MEDICAL DEVICE CORRECTION

RE: Prismaflex Control Unit software upgrade

November 19, 2019

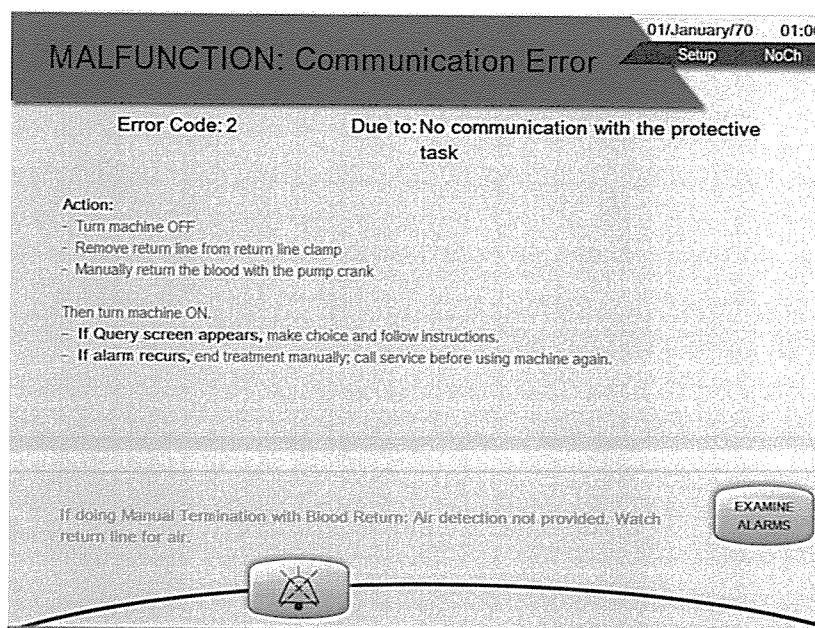
- The Prismaflex control unit enters a “safe state” by stopping all pumps and closing the return line clamp. Treatment is suspended. The patient’s blood does not circulate through the blood flow path.
- Red flashing light
- Recurring high-pitched sound of 10 sound pulses repeated approximately every 8 seconds until muted.
- Malfunction screen appears on the display as pictured below. The instructions to the user are the same for all error codes.

1. Operators may continue to safely use the Prismaflex control units until the upgrade is performed. If a communication error alarm does occur, follow the instructions presented on the graphical user interface and/or in the operator's manual. Please reinforce the importance to manually return the extracorporeal blood to the patient, and re-train users on this process, outlined on page 10:57 of the operator's manual, if necessary.
